On August 8th, 2016 Mr. Bisbee sent his “**Second Response to Geotechnical Test Boring Questions**” to Craig Rennie at the NH Department of Environmental Services. I have now tracked down his first response.

Intevenors attempt to navigate NPT document dump.

Re: Northern Pass Transmission Project – Geotechnical Test Borings

Photograph 1: “Mud bucket” set up for geotechnical borings.

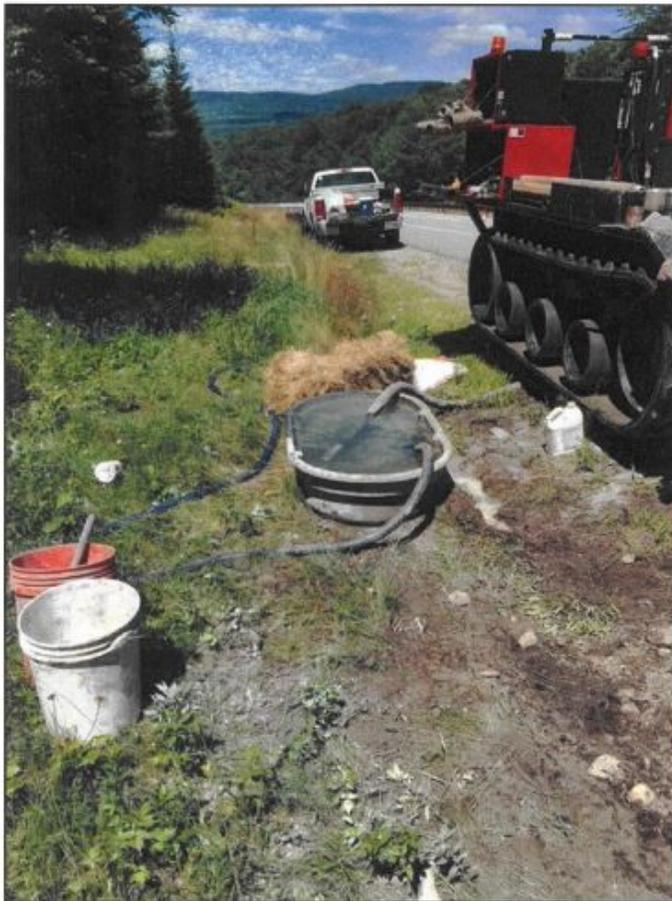
The slurry (usually in the tub, which appears filled with water for this photo) was not directed toward the hay bale. This is clearly shown in the photo, where the slurry mess is uphill of the tub, left and slightly downhill from the borehole. The slurry is comprised of water, drilled material, bentonite added for lubrication and to increase to viscosity of the fluid, and possibly polymer. “Suspended solids in discharge water” implies that the two things are easily separated and that the water is meant to be discharged, neither of which is true. One limp haybale is not BMPs. BMPs are frak tanks that circulate the drilling slurry, filter out the solids, re-use the slurry in the next hole, and dispose of the solids in the appropriate landfill. BMPs are silt fences and more (see list below.) There isn't supposed to be

slurry discharged from the drilling operations, “inadvertently” or intentionally.

Look at the slurry all over the ground in the photo on page one, near the tub, and the five gallon buckets into which they hand-shoveled the solids as they sunk in the tub. It is beyond belief that a spill of ten gallons of slurry would make it from the hay bale to the pick-up truck in the photo without being visible on the ground. I photographed the stream below that was clouded with sediment and there was no slurry on the ground above it, where the drilling was taking place. This, and the presence of boring slurry uphill from the tub argue for other events.

Photograph 2: Haybales used to filter discharge from mud bucket.

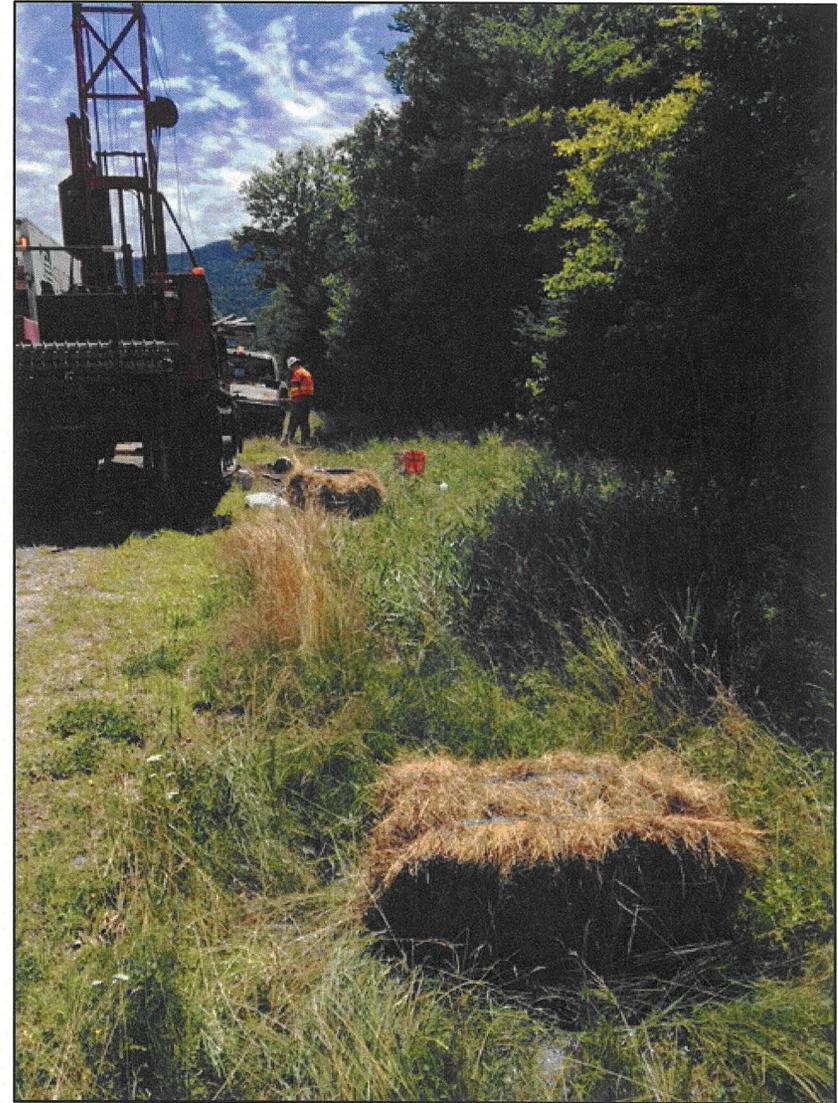
3. With respect to draining water into the roadside at the location in question, S.W. Cole had set up appropriate Best Management Practices (BMPs) in the field to contain water discharged from the drilling operations to prevent inadvertent discharges from reaching aquatic resources. In this location, the water was directed to a haybale containment/filtering BMP. (See attached photograph.) According to the boring contractors, the nature of the suspended solids in the discharge water was very fine and it consisted of stone dust and bentonite clay that are easily suspended in water. The intent of the BMPs was to filter the drilling water such that the fine materials would be removed and the water would infiltrate into the ground to prevent flowage into the nearby stream (unnamed tributary stream to the Wild Ammonoosuc River). However, because this site was on a slope having an uneven rocky ground surface beneath the vegetative cover, the drilling discharge water appears to have flowed more quickly than it could be fully filtered. As a result, some of the water containing the suspended solids reached the stream during the drilling operation in this location. Nonetheless, according to the drilling crews, the amount of release was very small (less than 10 gallons) and the milky discharge that traveled to the stream was minimal and quickly dissipated. PAR has assured Northern Pass that the appropriate BMPs will be implemented for the remaining test boring locations to avoid any similar discharge.
